Re: **NRC Docket 40-06563, NRC License STB - 401**
Mallinckrodt Inc. – C-T Phase II Decommissioning Plan
Appendix G and Chapter 5, "Dose Modeling"

Mallinckrodt's response to NRC staff requests for information concerning the C-T Phase II Decommissioning Plan are enclosed. By teleconference call, Mark Thaggard requested that the source terms for derivation of concentration guideline level (DCGL) on pavement and attenuation effect of pavement from cinder fill beneath be based on radionuclides observed by sampling. Explanation of DCGL on pavement in equivalent, measurable units was also requested. A new Appendix G to CT 2 DP describing derivation of DCGL_w on pavement and other explanations requested, a corresponding revision of CT 2 DP, section 5 Dose Modeling, §5.9, §5.10, and §5.11, and an updated Table of Contents of the Plan are enclosed.

APPENDIX G
DERIVATION OF DCGL_w ON PAVEMENT

This appendix describes a revised derivation of DCGL_w applicable to pavement and building slabs. Responses to NRC staff requests for additional information about this topic are also incorporated into this appendix.

Figure G-7. Refinement of CT 2 DP §5 Model for Pavement

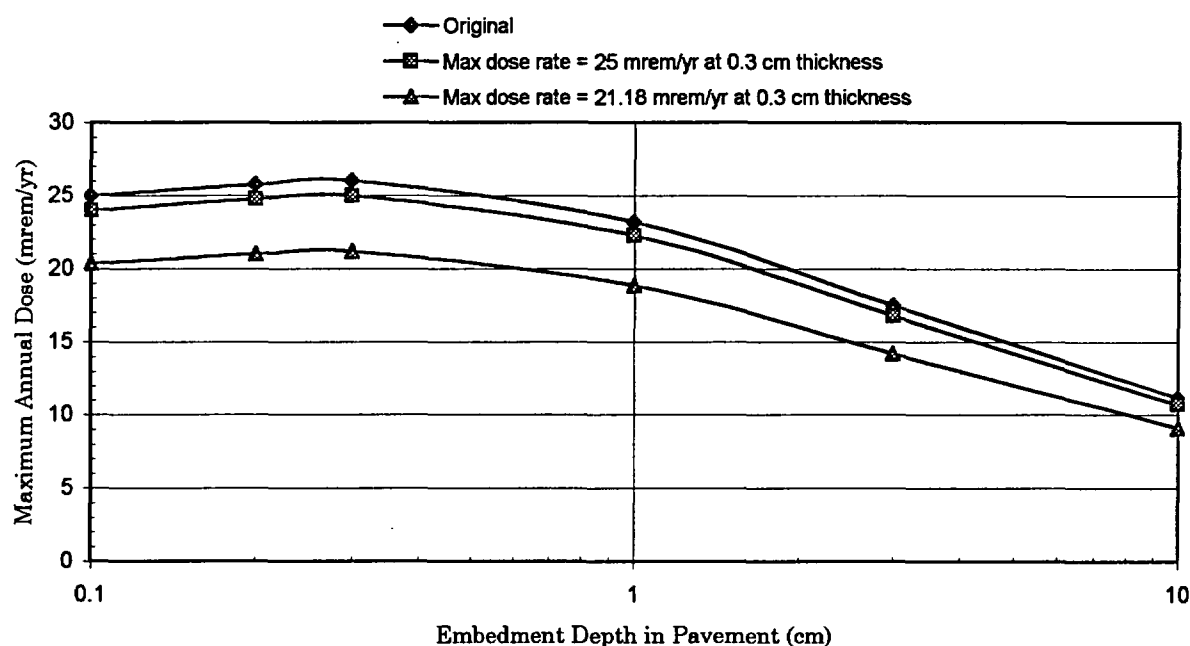
A premise of CT 2 DP, §5, original Table 5-3 was that an equivalent areal density of CT residue would produce less dose when embedded than when accumulated on the surface; hence the source was originally modeled as concentrated into a 0.1 cm layer on the surface. Unexpectedly, maximum total dose occurs when the source is 0.2 to 0.3 cm thick, or deep, as illustrated in Figure G-7, curve “♦ Original.” This observation prompted derivation of DCGL_w assuming 0.3 cm contaminant thickness of the long-lived radionuclides in the uranium series, the actinium (U²³⁵) series, and the thorium series, assuming short-lived nuclides (<180 day half-life) to be in transient radioactive equilibrium with their parent. The result of this refinement is illustrated in Figure G-7 by the curve, “■ Max. Dose Rate = 25 mrem/yr at 0.3 cm thickness”. Thus, if contamination were on the surface or even if it were unevenly embedded into pavement or a building slab, assuming 0.3 cm source thickness when deriving DCGL_w by dose modeling would assure maximum annual dose as a function of source areal density.

If the inventory corresponding to the areal DCGL_w derived for the surface of pavement were embedded or migrated downward into pavement, the dose would diminish because of internal shielding of gamma radiation by pavement material. The inventory to be allowed on pavement surface corresponding to the areal DCGL_w proposed in Table G-6 would be less than inventory in about 4 cm of topsoil at the DCGL_w specified in CT 2 DP Table 5-1 (rev. March 20, 2006).

That is, in a nominally representative mixture of 3 U series -to- 1 Th series, the areal density at the DCGL_w on pavement or a building slab is the same as the areal density equivalent of the DCGL_w concentration in about 4 cm of soil. Or, if radioactive source material at the DCGL_w in the top 4 cm of topsoil were concentrated at the surface, the areal density would be the same as the DCGL_w applicable on the surface of pavement or a building slab. In perspective, then, the relation in radioactivity between the DCGL_w derived for application on pavement or a building slab and separately in topsoil is a reasonable one.
